Zoning Board of Appeals
Wednesday, September 11, 2024
5:30 PM

- 2. ZBA 2024-008: Design Review** for Approval of a **556 SF Addition** at **New Life Tabernacle Church** located at **54XX Reimer Drive** (PIN: 04-33-128-009).
[Property Owner: New Life Tabernacle]
- 3. Discussion and review** of current regulations relating to **Sec. 15-555 Private Solar Energy Collection Systems**

Zoning Board of Appeals Meeting of September 11, 2024**Application No. ZBA 2024-008****To:** Village of Roscoe Zoning Board of Appeals**From:** Evan Hoier, Vandewalle & Associates – Village Consulting Planner**Date:** August 20, 2024**Re:** New Tabernacle Church Meeting Hall Addition**Background**

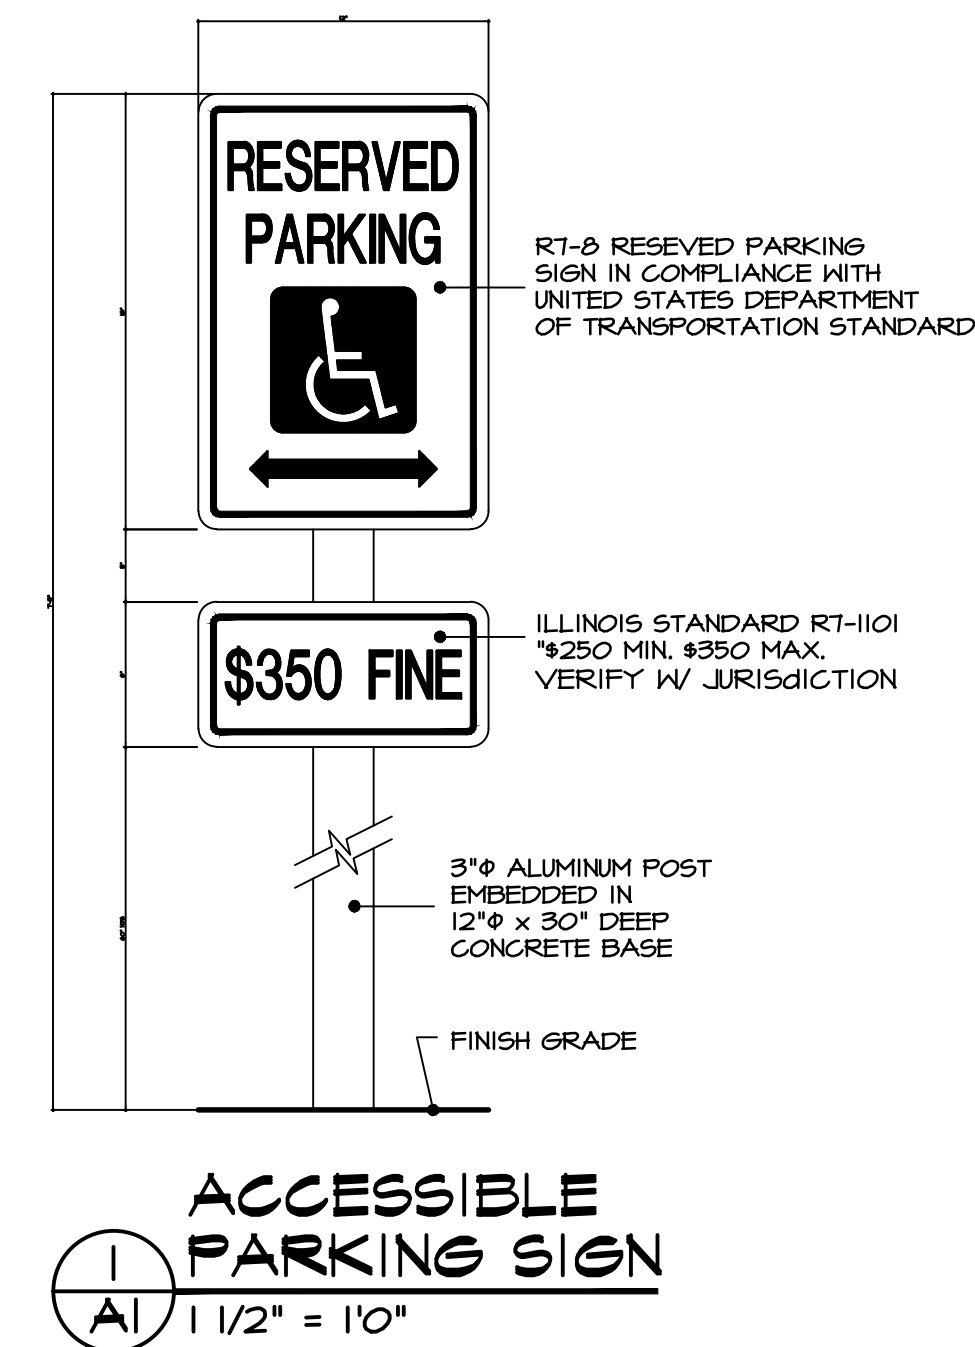
Upon review of Google Street View, there is an existing dumpster enclosure located in the front yard of the site. The screening material around the dumpster appears to be chain link or a similar material, and does not effectively block the dumpster from public view at the right-of-way. Under both Section 15-437 *Development Standards Applicable to Commercial Districts* and Section 15-661 *Additional Landscape and Screening Requirements*, trash and dumpster enclosures are required to have an opaque material on the outside of the enclosure to effectively screen from public view. As a condition of approval, additional or replacement siding on the enclosure will be needed.

1. Color selections on the proposed addition must match those on the existing meeting hall building.
2. Additional or replacement siding on the existing dumpster enclosure in the site's front yard is required.

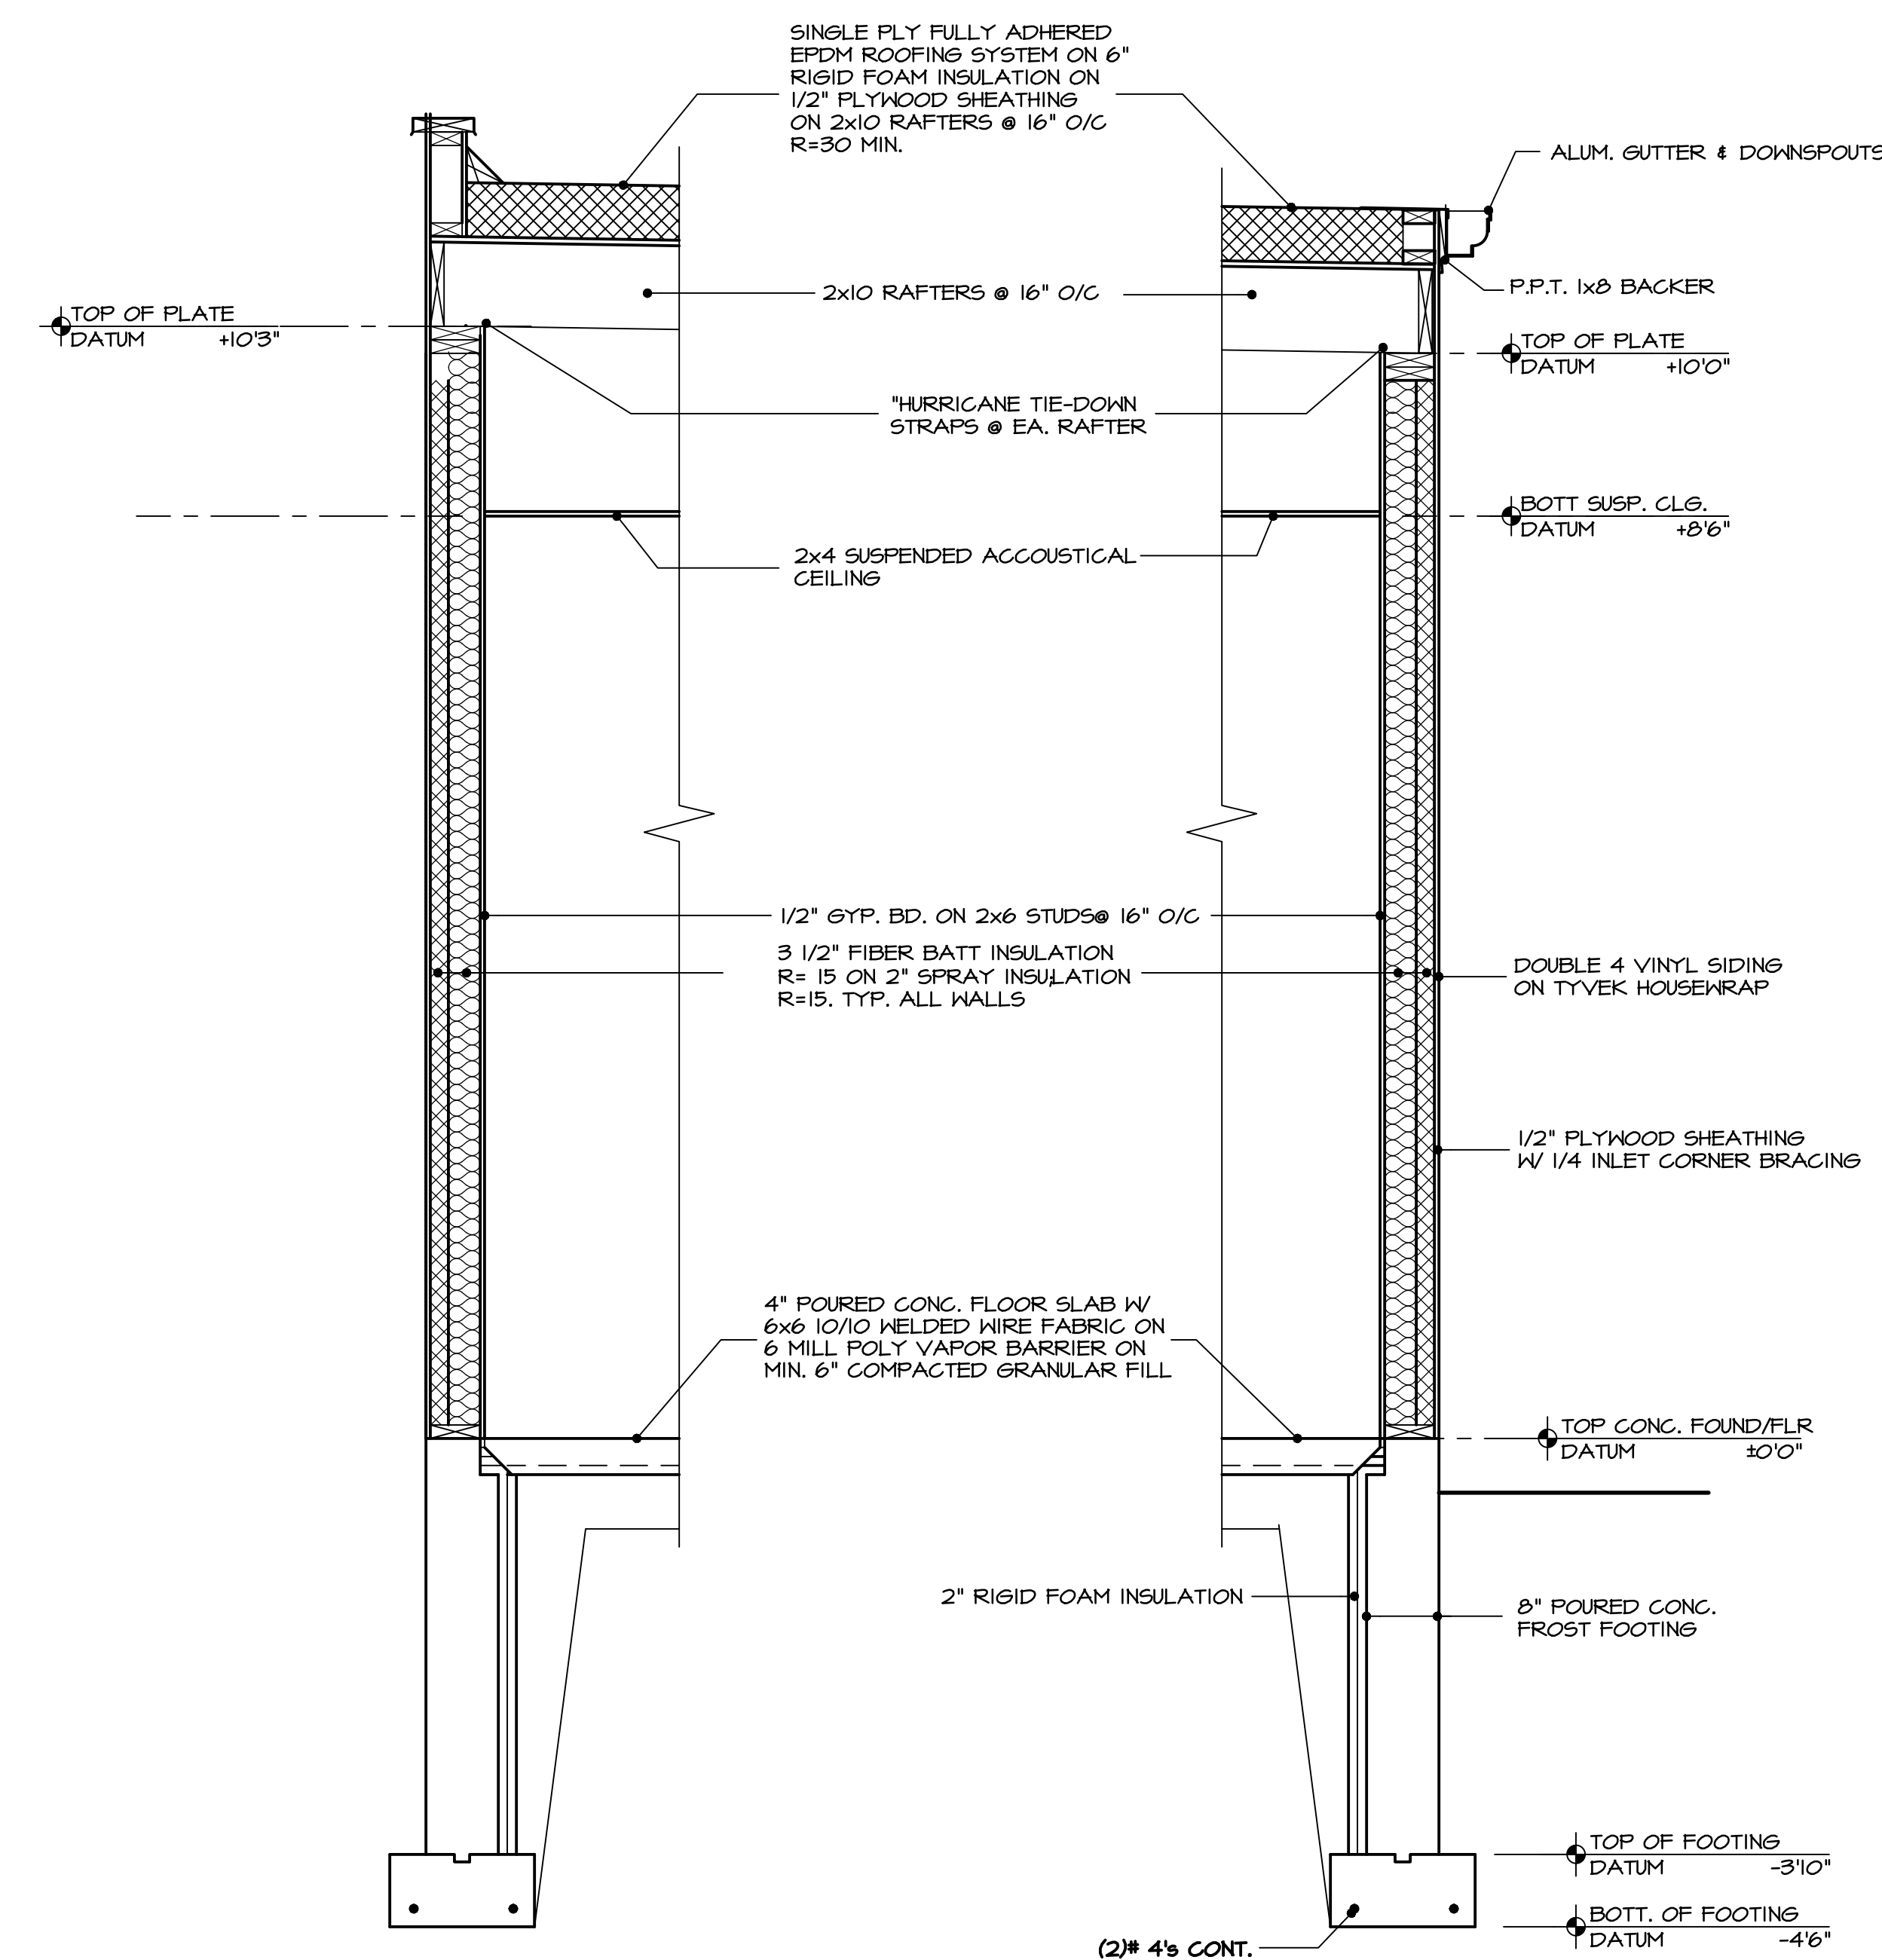
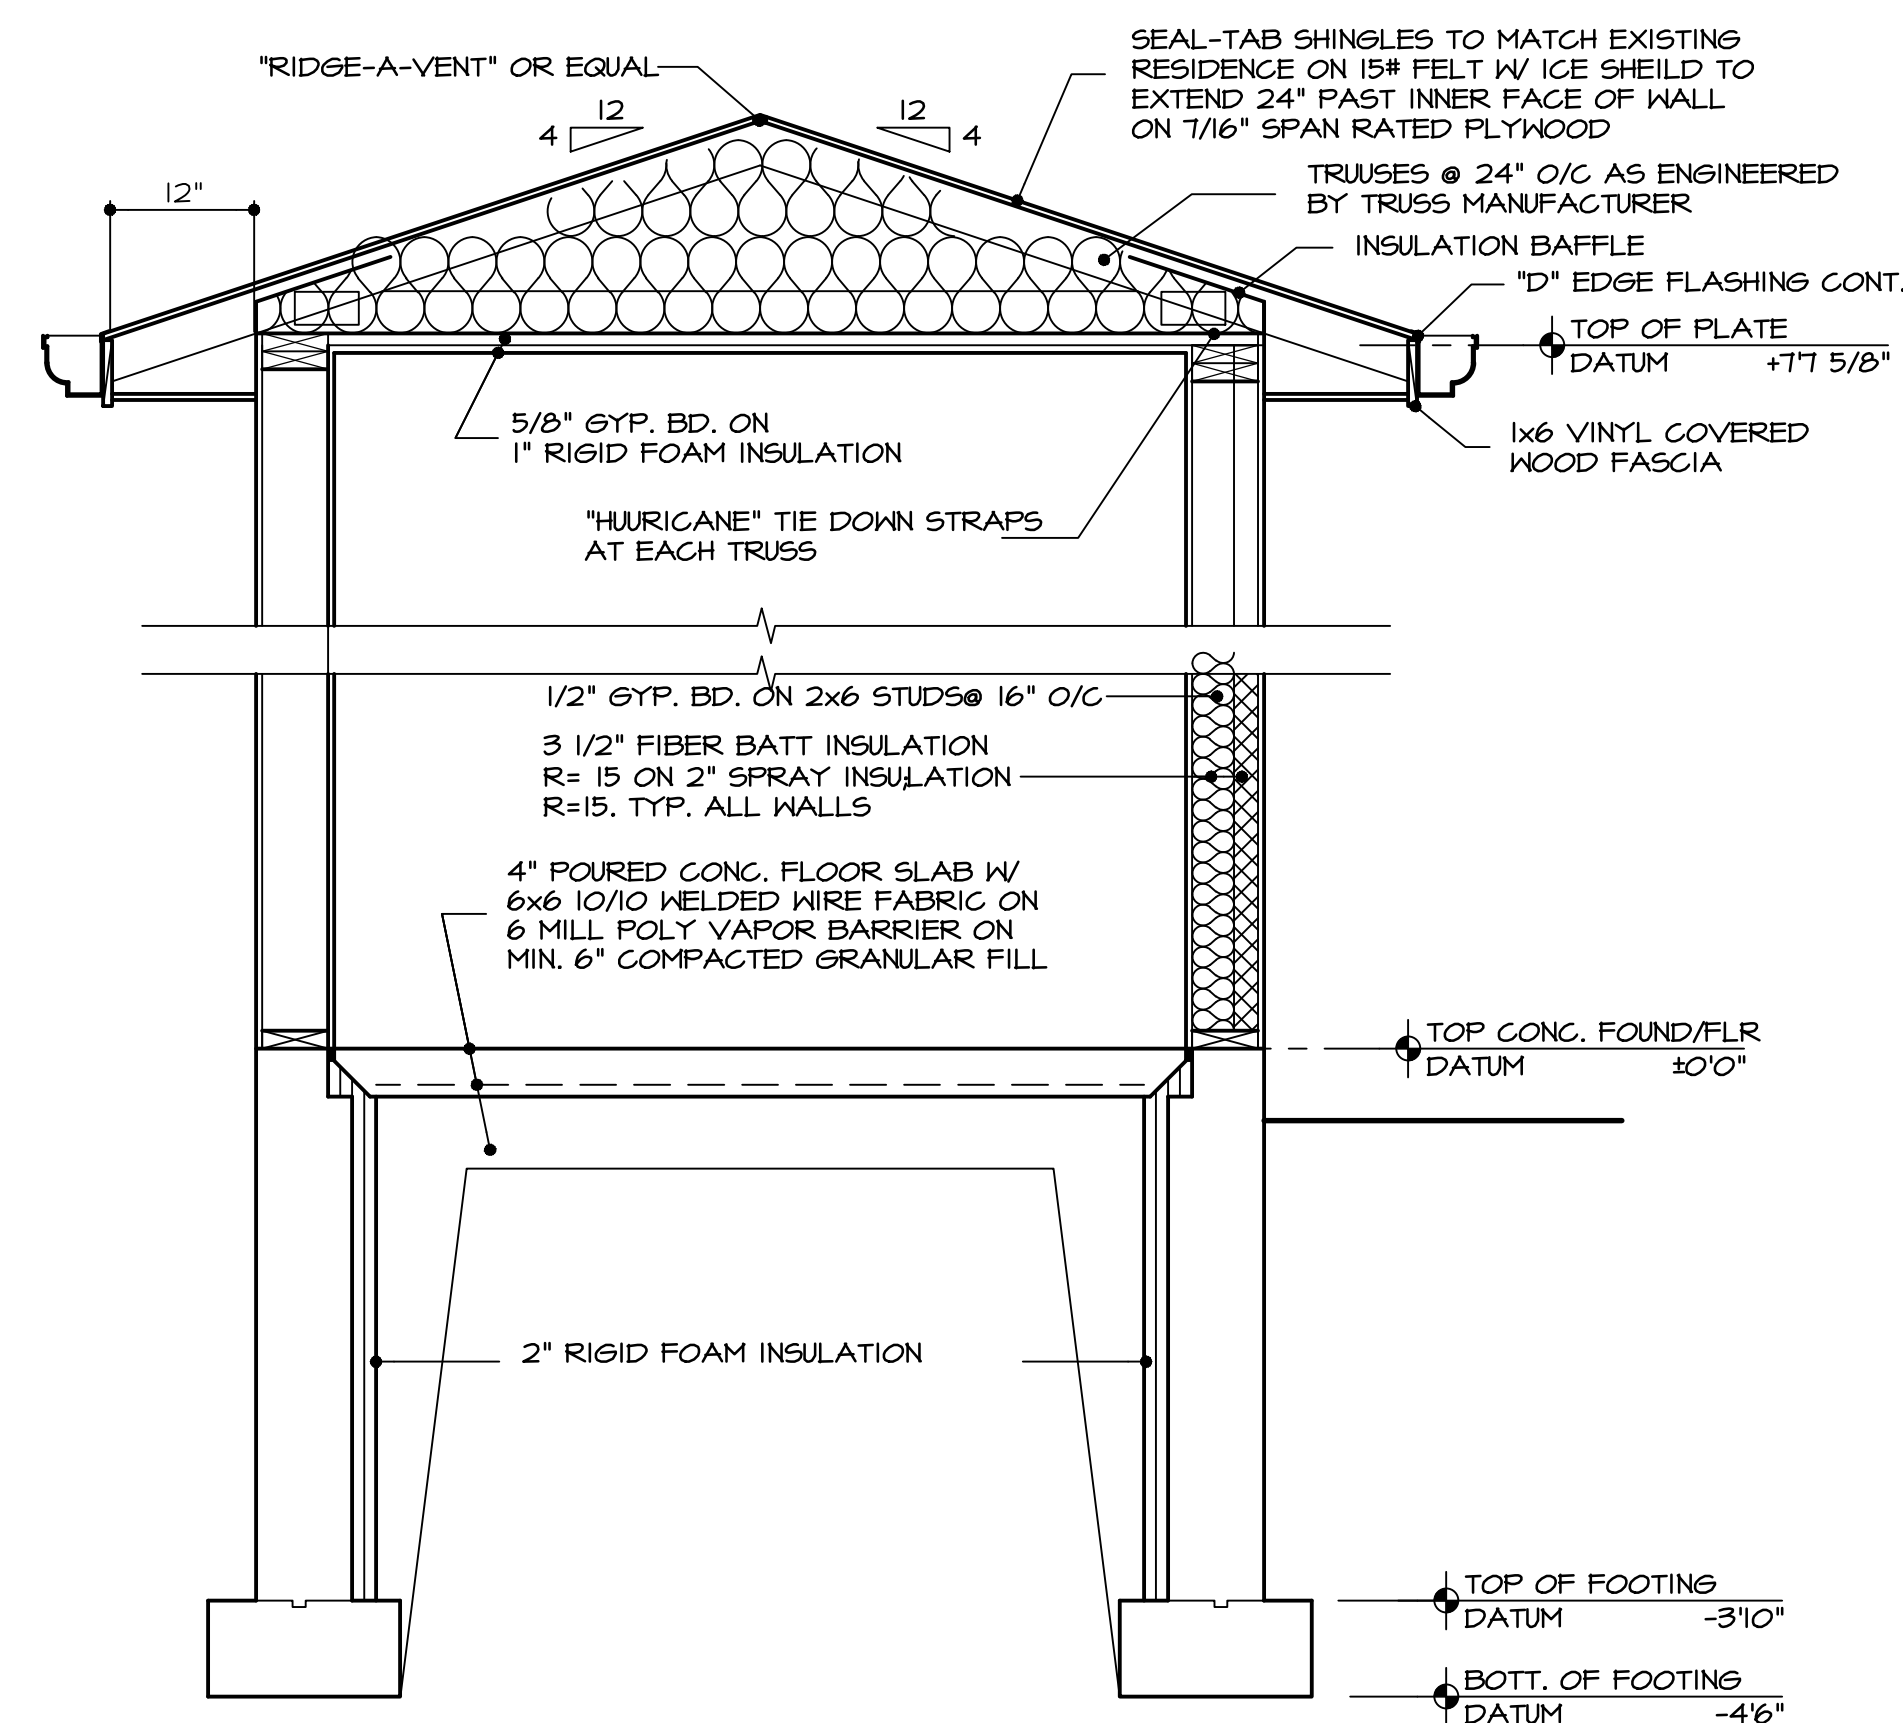
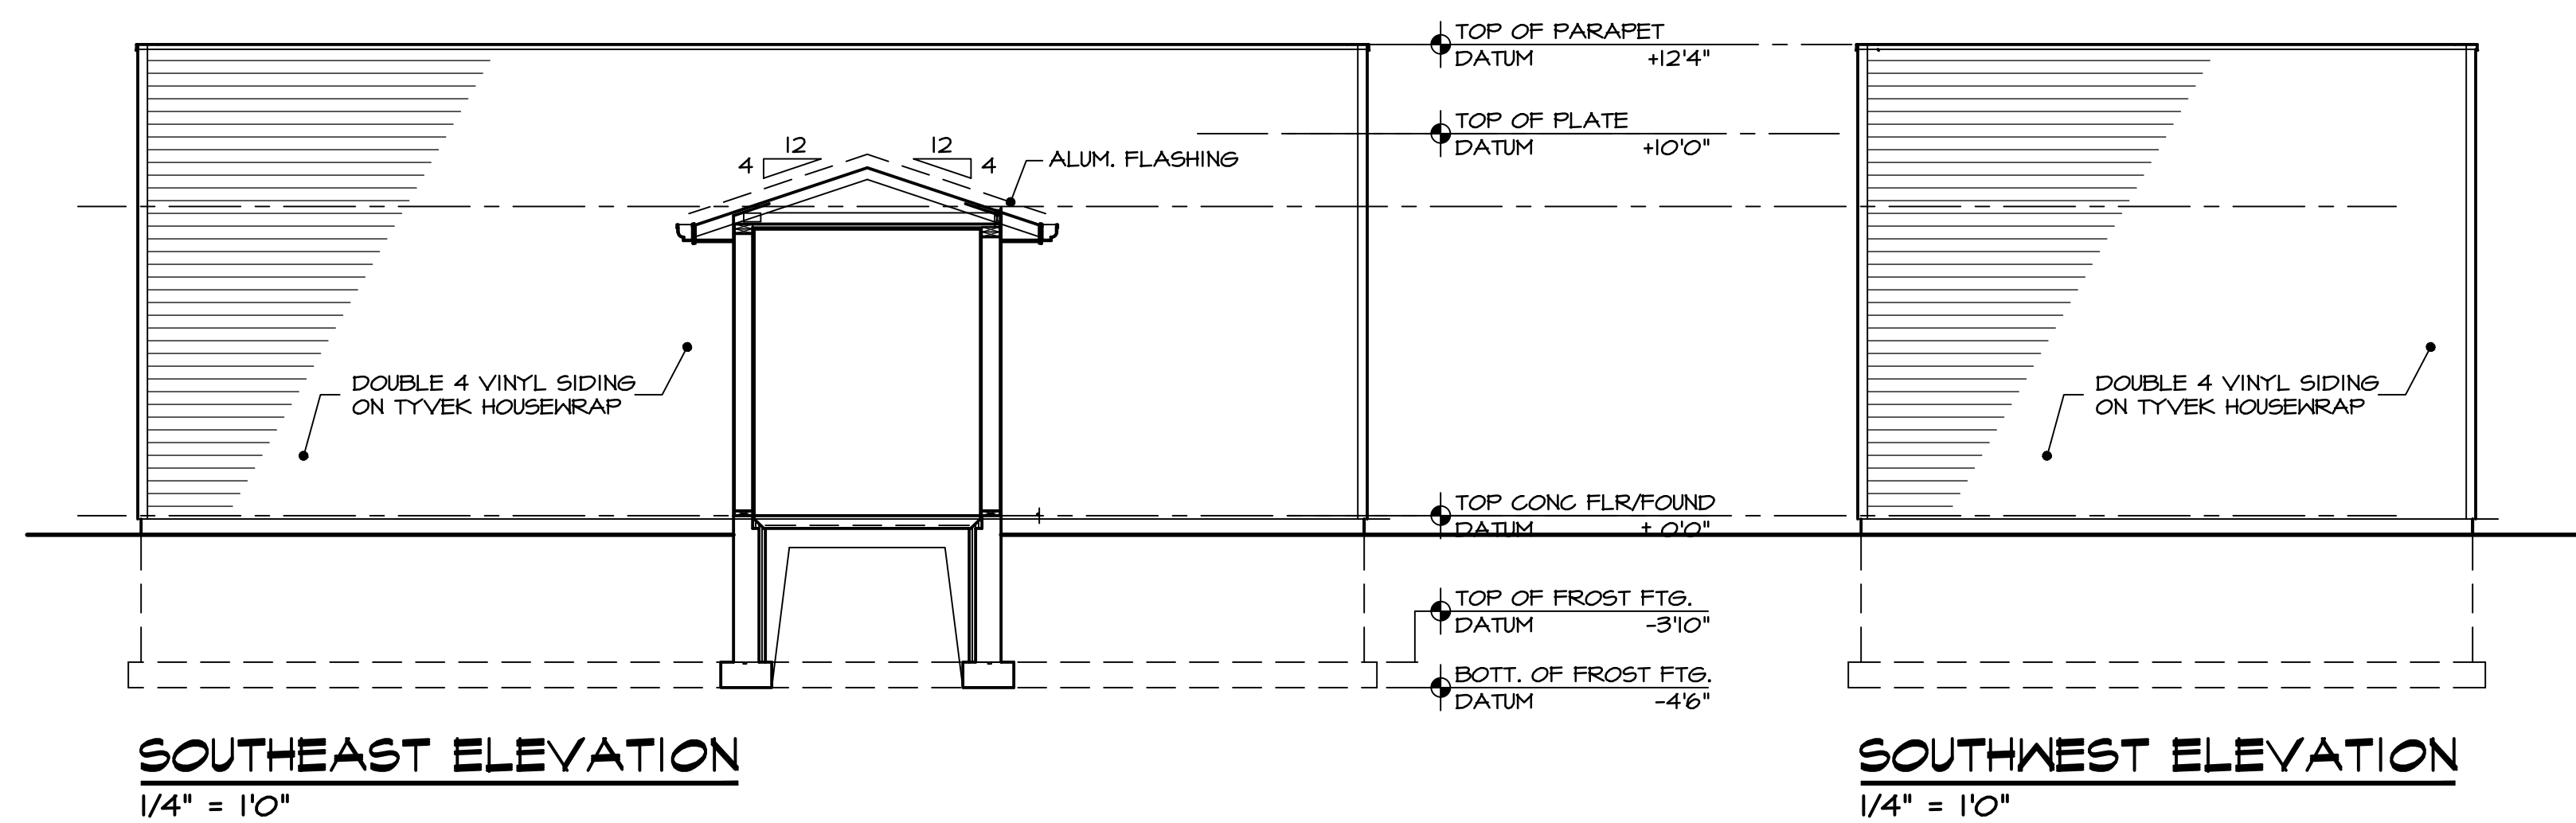
The proposed addition will be 556 square feet, connected by a walkway between the existing building and the proposed area. This walkway will have a gabled roof connected into the existing building's roofline, perpendicular to the main pitch. The majority of the addition will be sided by Double 4 vinyl siding to match the siding on the existing building. Also to match, the shingles on the addition will match those on the existing roof.

There are 2 windows on the addition, one on the northwest elevation, the other on the northeastern elevation. These windows will have vinyl shake siding above and below them to match the windows on the elevations of the existing building. The elevations provided by the applicant do not show any color variations planned. As a condition of approval, any

and all elements of the exterior of this proposed addition must be consistent with colors on the existing building.
